City of Portland, Maine – Building or Use Permit Application 389 Congress Street, 04101, Tel: (207) 874-8703, FAX: 874-8716

Location of Construction: 11 Exchange St		Owner: Soley, Joseph		Phone:		Permit No: 980435 PERMIT ISSUED Permit Issued: APR 30 1998 CITY OF PORTLAND Zone: CBL: 032-F-012
Owner Address:		Lessee/Buyer's Name:		Phone:		
Contractor Name: Joe Soley		Address: IGENE P.O. Box 367 Fald, ME 04101		Phone: 774-7777 - P.J.		
Past Use: Apt Building Mix Use Bldg		Proposed Use: Same		COST OF WORK: \$ 500.00 PERMIT FEE: \$ 25.00 FIRE DEPT. <input type="checkbox"/> Approved <input type="checkbox"/> Denied INSPECTION: 11 Use Group: Type:		
Proposed Project Description: Re-Flag existing deck				Signature: _____ Signature: _____ PEDESTRIAN ACTIVITIES DISTRICT (P.A.D.) Action: <input type="checkbox"/> Approved <input type="checkbox"/> Approved with Conditions <input type="checkbox"/> Denied Signature: _____ Date: _____		Zoning Approval: Special Zone or Reviews: <input type="checkbox"/> Shoreland <input type="checkbox"/> Wetland <input type="checkbox"/> Flood Zone <input type="checkbox"/> Subdivision <input type="checkbox"/> Site Plan maj <input type="checkbox"/> minor <input type="

TOP View of Deck

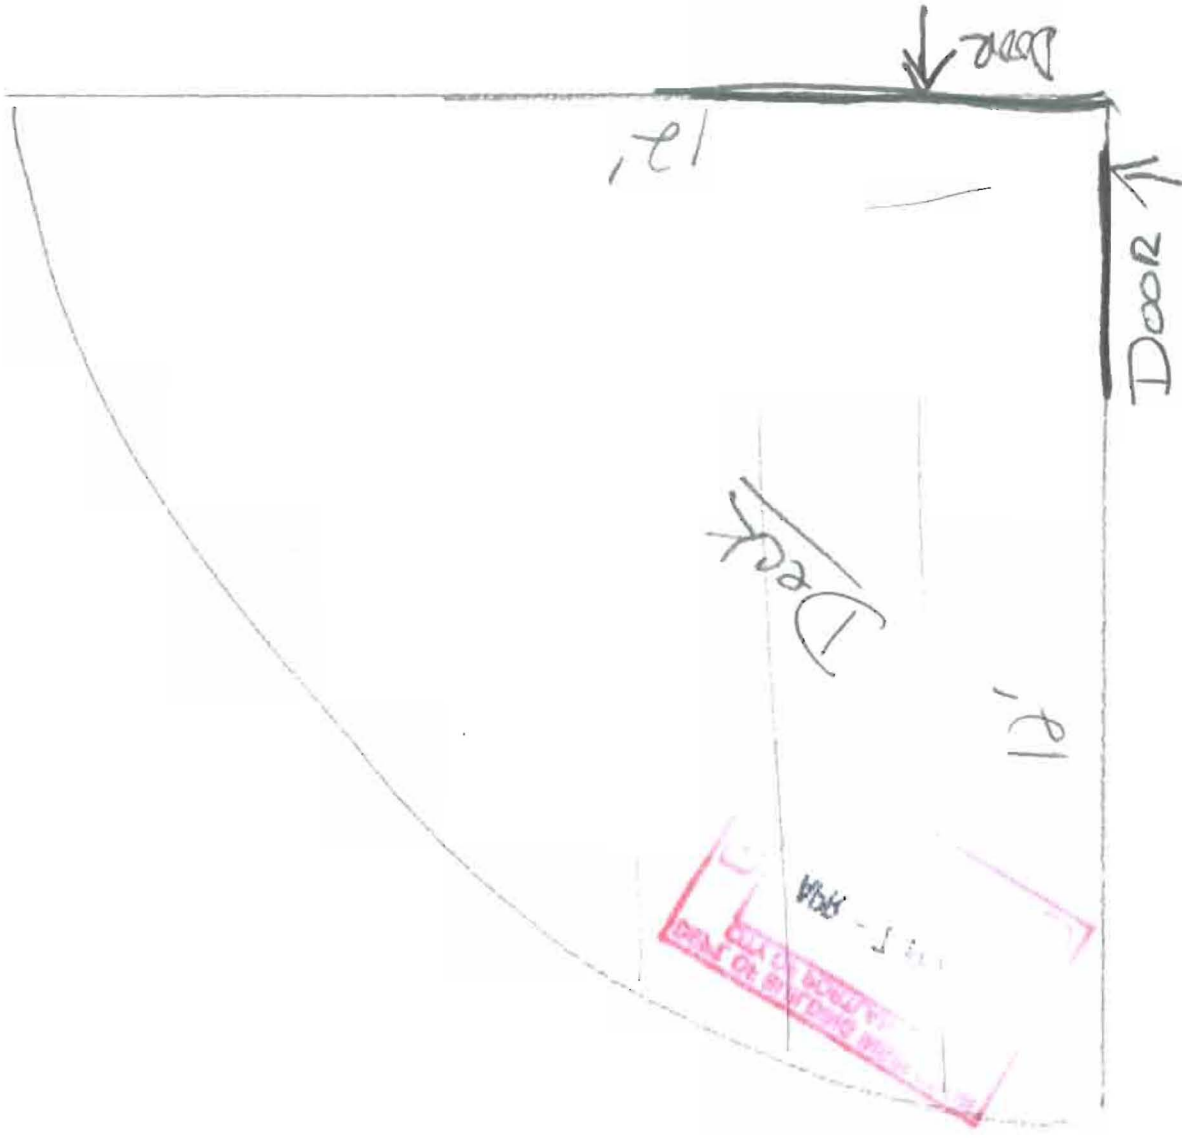
Approved with the following conditions: *5 *8 *10 *26 *29 .

I Insp. 11 Exchange
for Hist. Pres. It appears
that new joist have been
installed and floor decking
you may want new spec's
submitted or amendment.
